To: Rob Balland, PE
From: Pat O'Mahony, Associate Planner; 910-341-0189
CC: File;
Date: 1/23/2020
Re: Tru Colors Brewery TRC Rev. 3

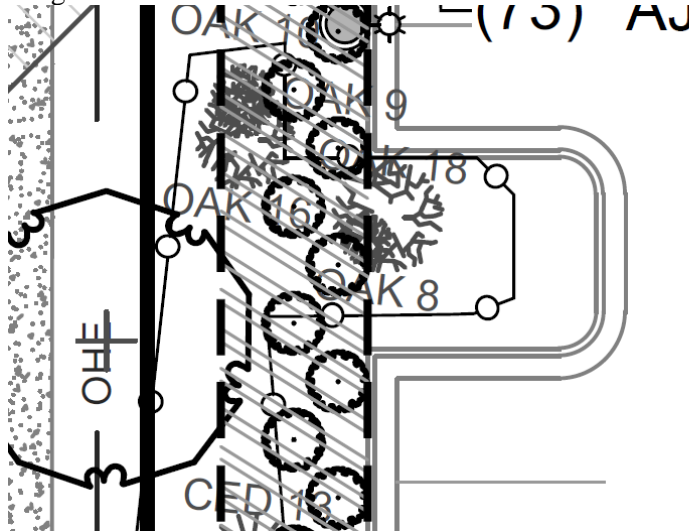
- All planting islands shall have additional ground cover or shrubbery from the approved plantings list to cover the entire landscape island.
 - No groundcover or shrubs shown in the island below
